**Moorabool Planning Scheme Amendment C103moor  
Hopetoun Park North, Bacchus Marsh**

**Panel Report**

**14 November 2025**

**Figure 7** Aboriginal cultural heritage sensitivity mapping

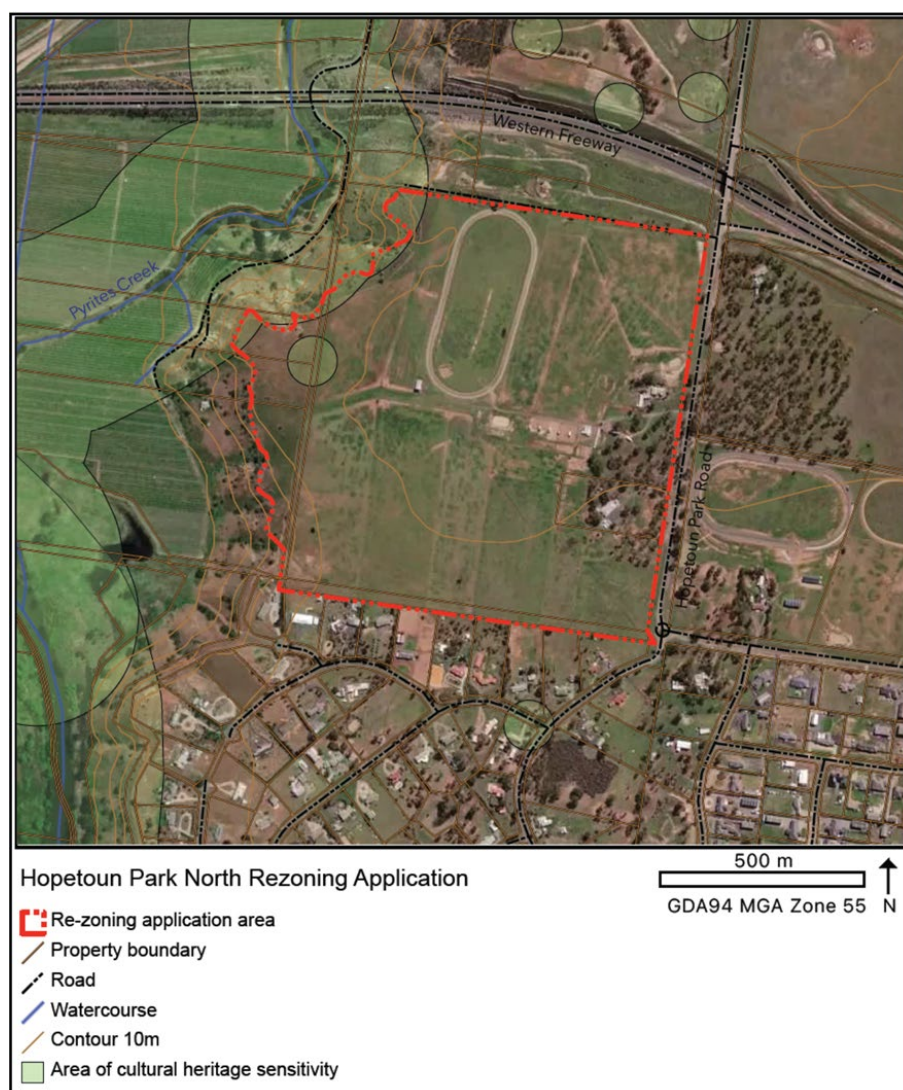
The Wurundjeri Woi-wurrung Cultural Heritage Aboriginal Corporation identified that a CHMP would be required for subdivision and requested that future development avoid the areas of cultural heritage sensitivity which are shown on Figure 7.

Council accepted that a CHMP was not required at the Amendment stage or in the preparation of a development plan, but the subdivision of the land would be considered a high impact activity which triggered the need for a CHMP. It submitted<sup>9</sup>:

In response to the submission of Wurundjeri Woi-wurrung Cultural Heritage Aboriginal Corporation, Council initially proposed to require a CHMP as a requirement of the development plan and that it be to the satisfaction of Wurundjeri Woi-wurrung Cultural Heritage Aboriginal Corporation. At the Hearing and in its Part B submission Council reconsidered its approach<sup>10</sup>:

The Panel agrees with the Proponent that a CHMP or a CVA should not be a requirement for the development plan in DPO7. It does however support the oral evidence of Mr Granger that a voluntary CHMP at this point in the process to inform the development plan would be useful.

**Amend Clause 4.0 of the Development Plan Overlay 7 to delete the need for a Cultural Values Assessment as contained in Appendix C.**

**Figure 8** Escarpment survey plan

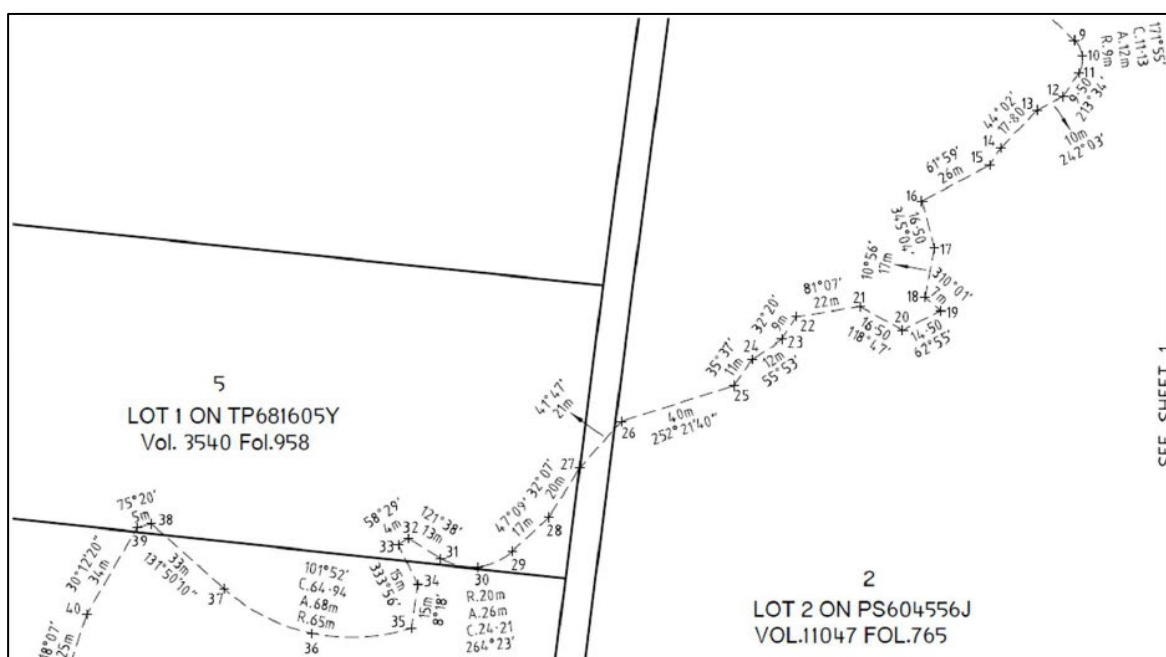
The location of the top of the escarpment on the western boundary is important as the new planning controls for the land take setbacks from this point. Millar Merrigan surveyed the escarpment and defined the top of the escarpment. Figure 8 contains part of this survey for the north west corner of the land.

The Proponent referred to the evolution of the setbacks along the escarpment. An initial report from Hansen Partnership that was not exhibited as a background report established the need for a setback from the escarpment comprising a 10 metre wide linear open space corridor, a 20 metre wide road reserve and a 10 metre front setback to dwellings. This provided a 40 metre setback to new dwellings. The 2020 Hansen report recommended a 17.3 metre wide road reserve, instead of 20 metres. The 2023 Hansen report recommended a 20 metre wide linear open space reserve, instead of 10 metres. This provided a minimum 47.3 metre setback to new dwellings.

The Proponent advised the yellow line on the concept plan (see Figure 3) attached to DPO7 shows the 20 metre wide linear open space reserve.

Figure 9 Design guidelines for escarpment lots

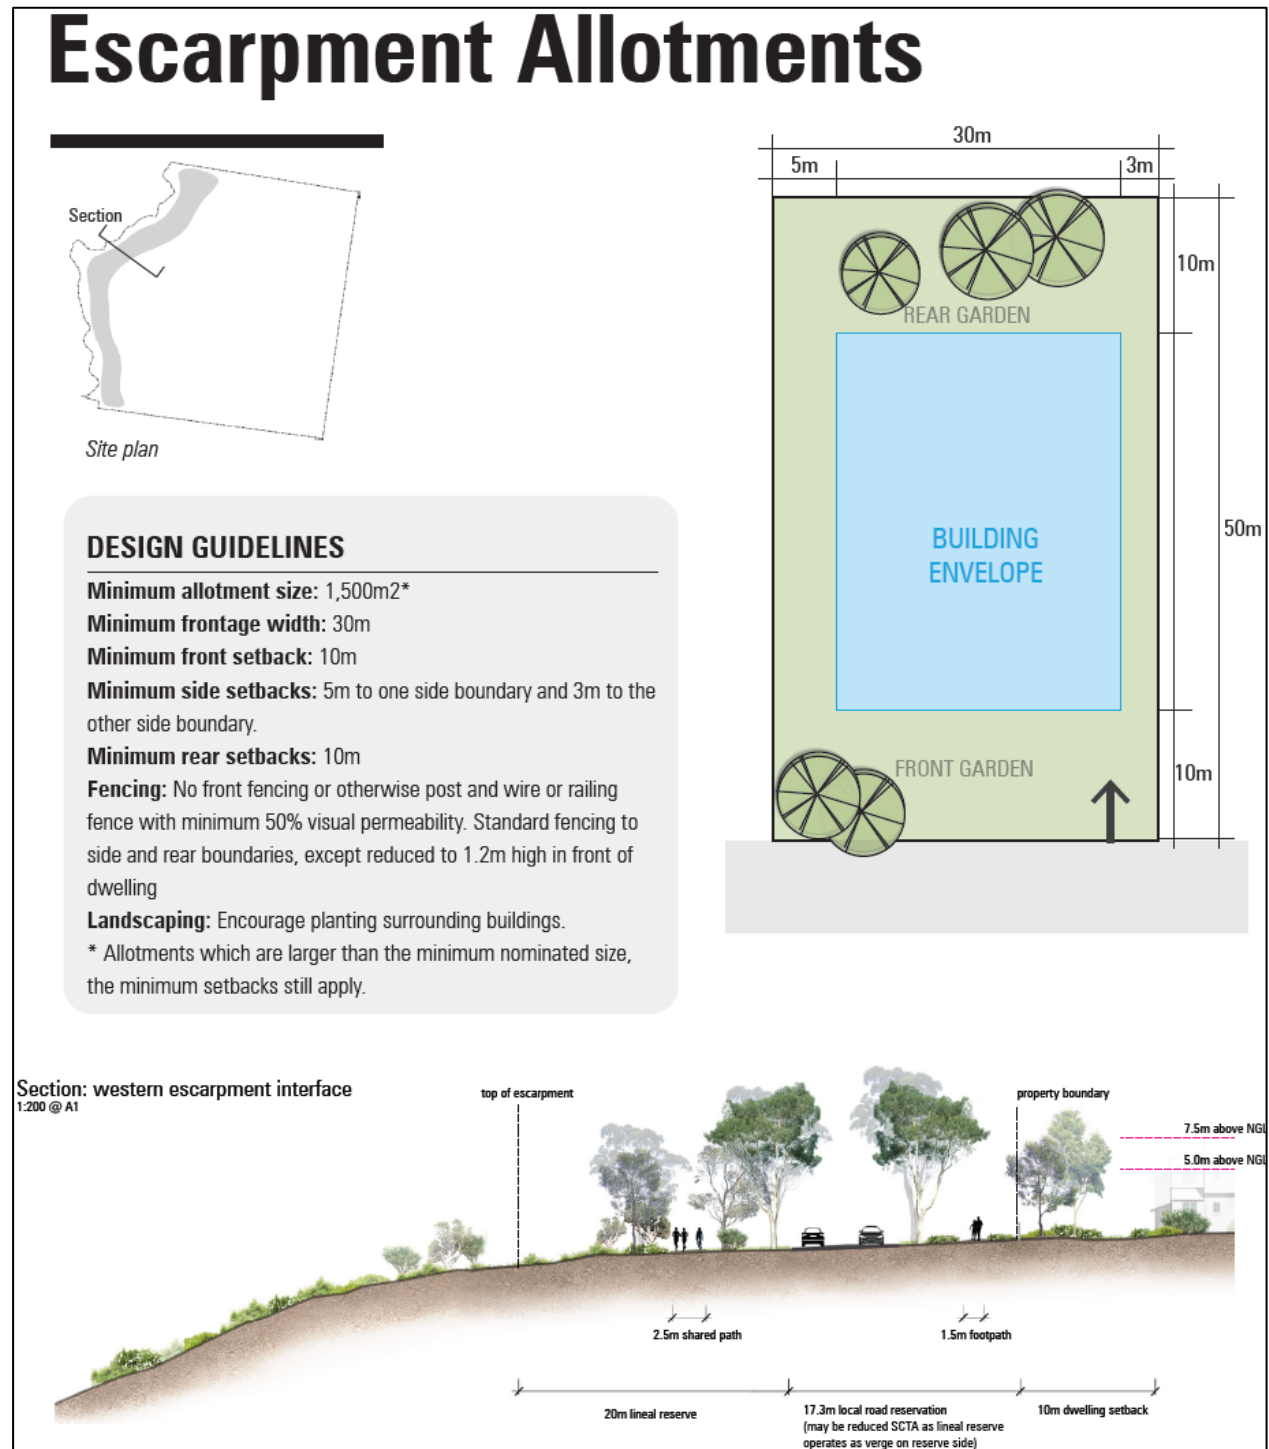
The proposed planning controls in this area are depicted in Figure 9 which shows the escarpment interface.

Council submitted the 2023 Hansen report recommended an 8-wire farm fence to be either located at the top or bottom of the escarpment to prevent public access.

Council considered *“this generous setback will ensure future built form is well separated from the existing properties.”*

**Figure 10** Interim western interface

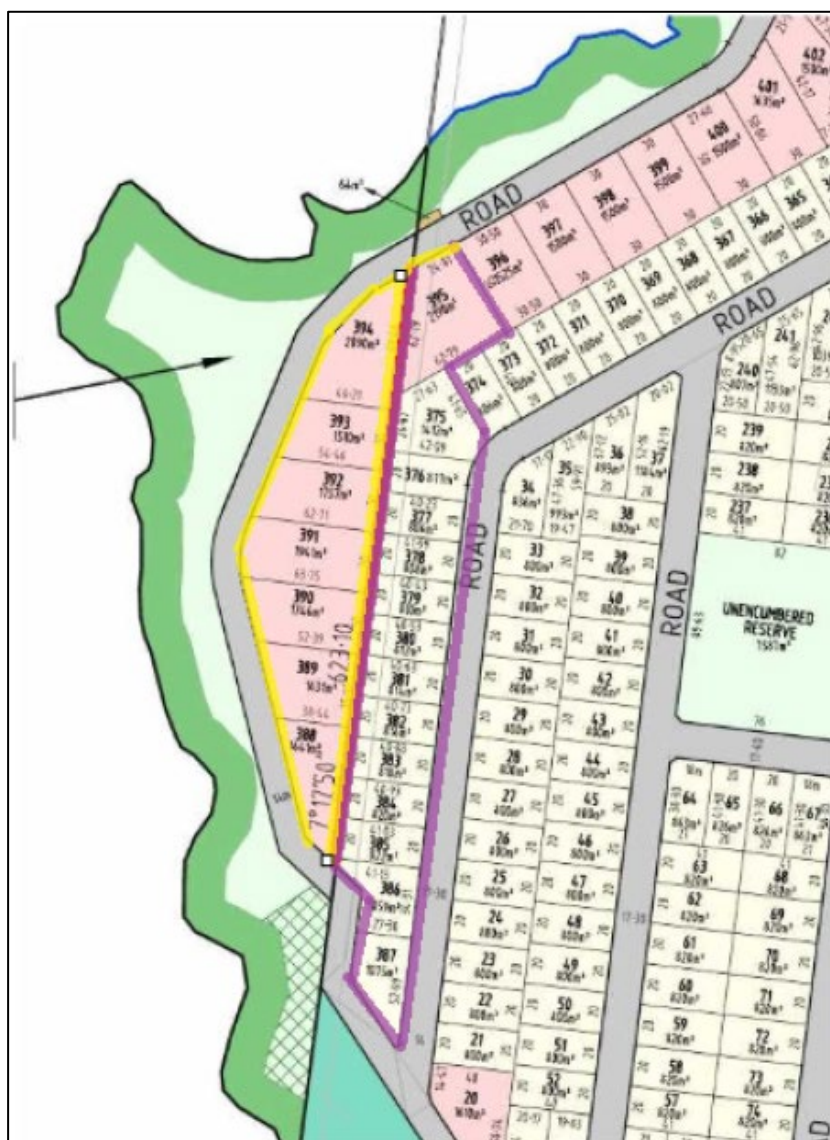
Figure 10 contains an excerpt of this area from Mr Shutt's evidence statement. The land circled in yellow is currently not owned by the Proponent. The effect of the Council's proposed condition is that the western interface escarpment road would need to be provided to the east of the yellow lots or those lots circled in purple could not be developed until a western escarpment interface road has been constructed.

If a Western Escarpment Interface Road has not been constructed, any permit for the subdivision of 124 Hopetoun Park Road must include a condition relating to any lots within 100 metres of the west boundary of Lot 3 on PS604556J, prohibiting any fencing presenting towards the escarpment to the west unless the fence is of a rural post-and-wire style, until such time as a Western Escarpment Interface Road is constructed, after which time the prohibition shall not apply, and requiring the planting of vegetation along any west-facing residential lot fence line prior to the issue of a Statement of Compliance, unless otherwise agreed in writing by the Responsible Authority.

**Figure 11** Area B Interface and Design Guidelines

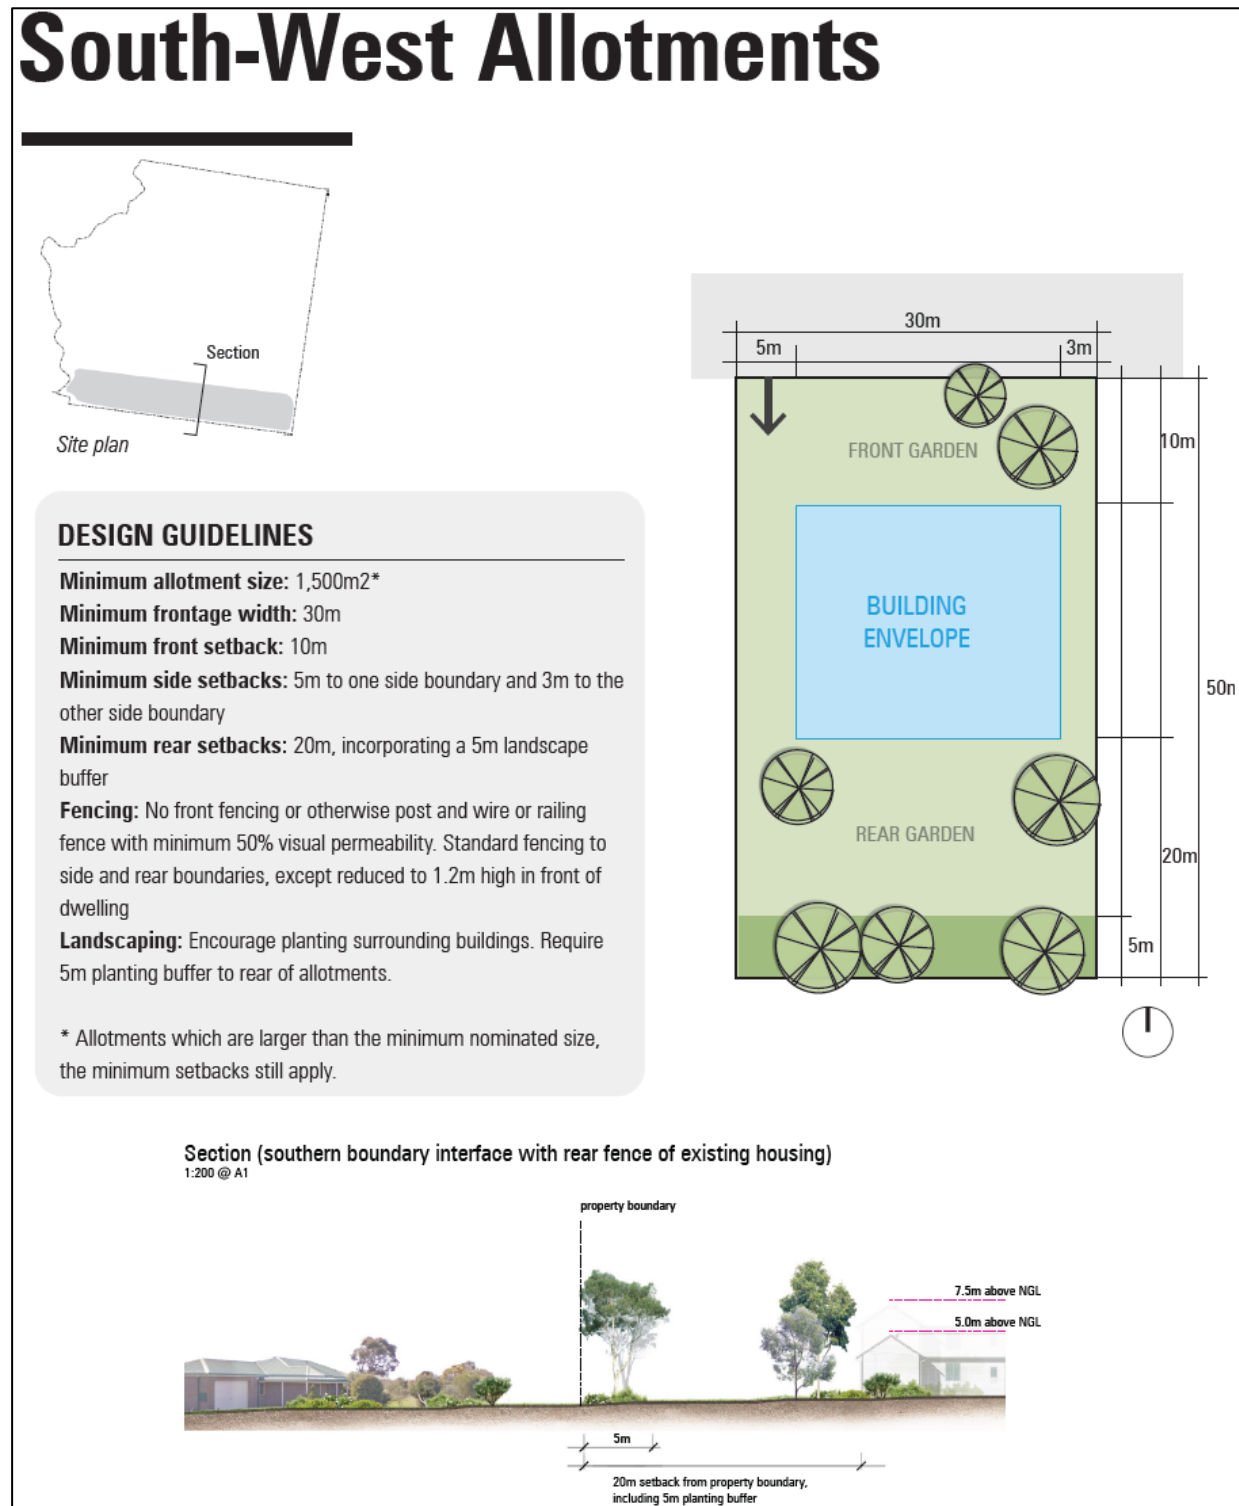
The proposed planning controls are depicted in Figure 11 which shows the southern interface lots. The setbacks result in a building envelope of at least 440 sqm.

Mr Schutt sought to clarify the intent of the 20 metre rear setback and confirmed the 5 metre landscaped area should also be a 'no build' area. The revised text for this part of the DDO17 is:

20 metres, which must include a 5 metre landscape buffer on the southern boundary. No outbuildings can be located within the 5 metre landscape buffer.

The Panel agrees with Mr Schutt that the 5 metre wide landscaped strip should be a 'no build' area. Both Council and the Proponent supported this change to DDO17. This will still provide for a building envelope which is at least 440 sqm in area. The Panel considers there is ample area for a new dwelling with the proposed setbacks, and it will assist in meeting the transition of this area to existing development.

**Figure 1: Areas A, B and C, hazard interfaces and relevant bushfire setbacks**

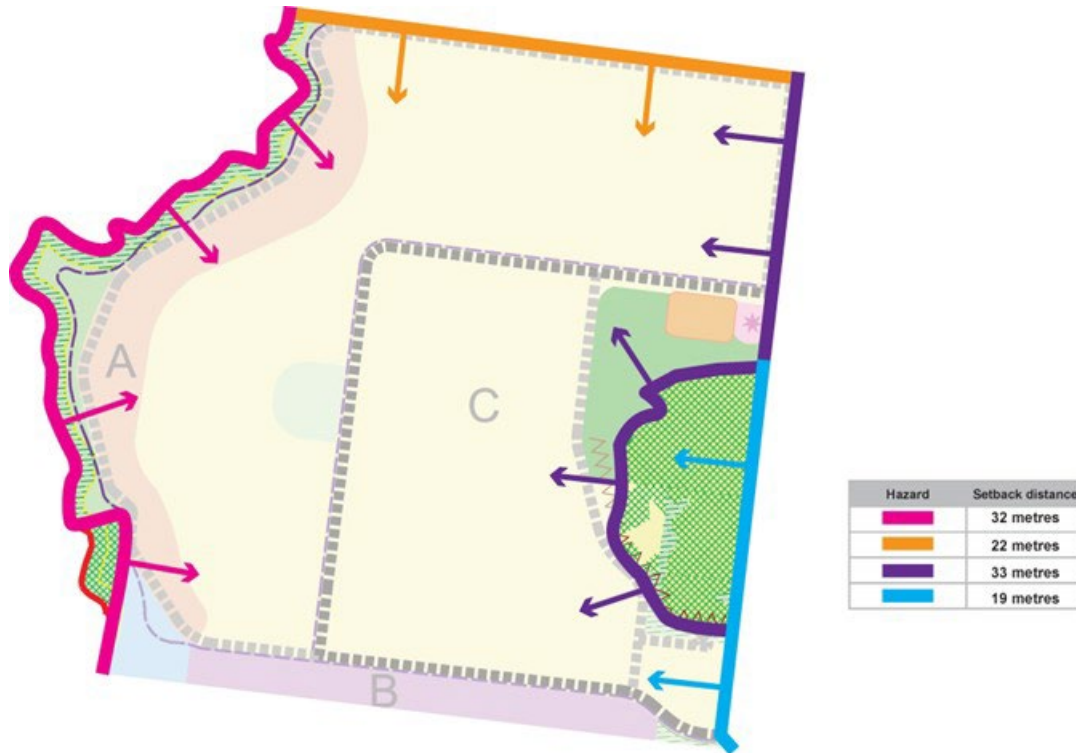
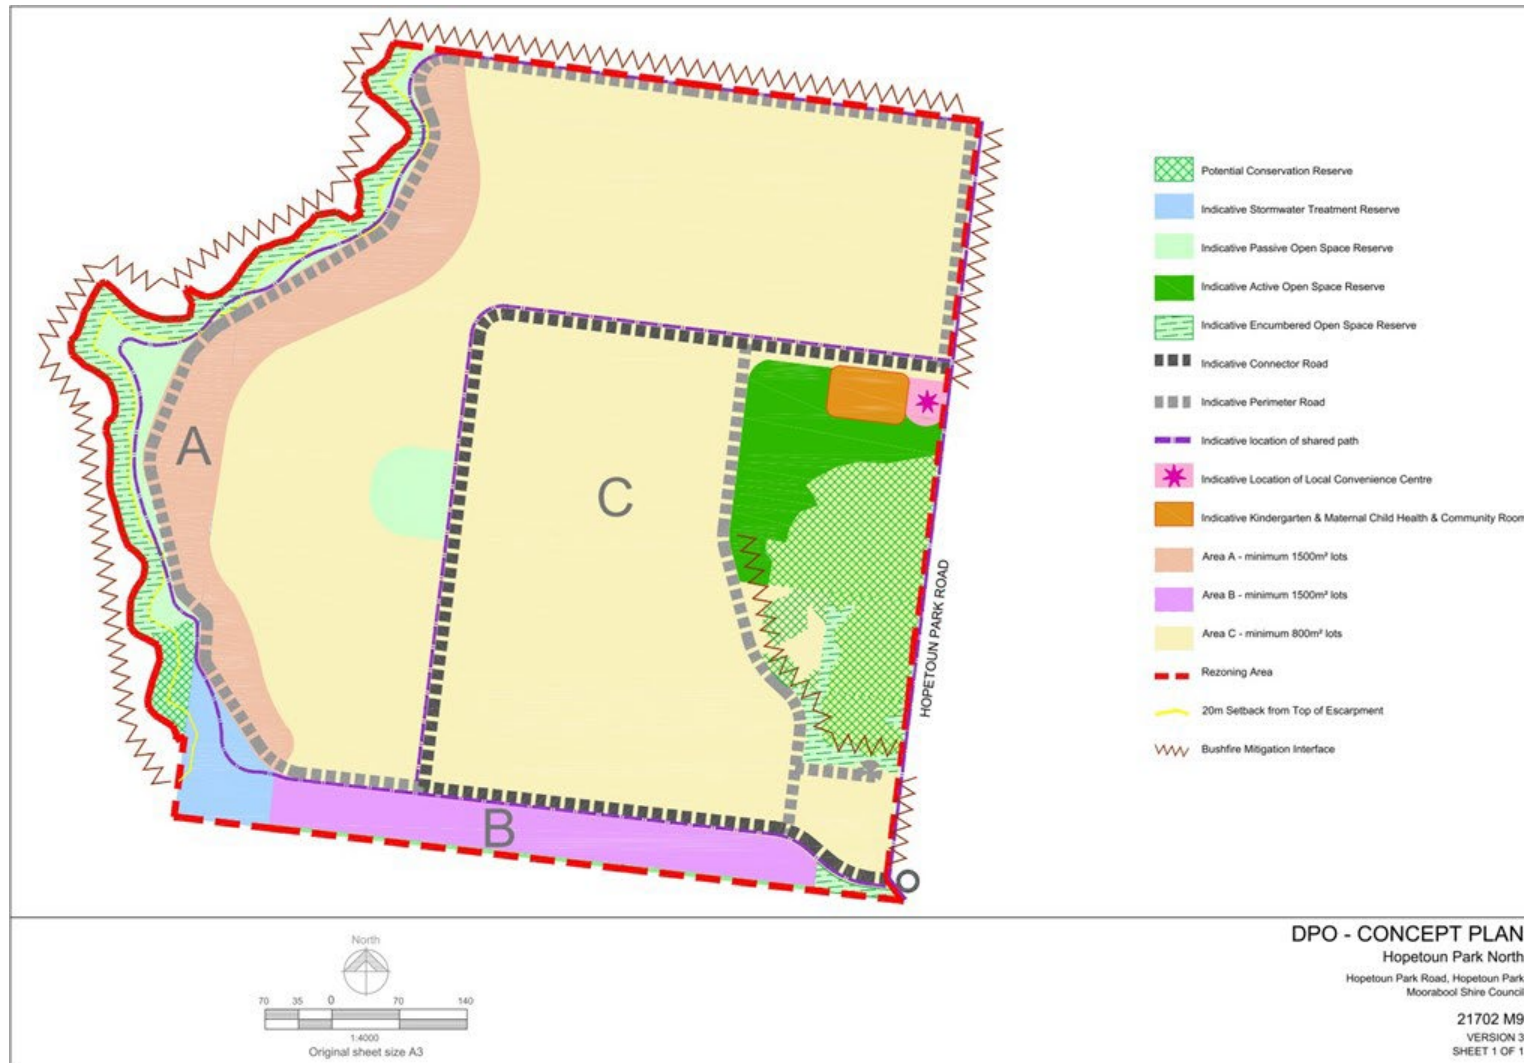
The Panel notes Figure 1 and Map 1 of DPO7 need to be updated to reflect the most recent agreed versions. This should be done prior to the gazettal of the Amendment.
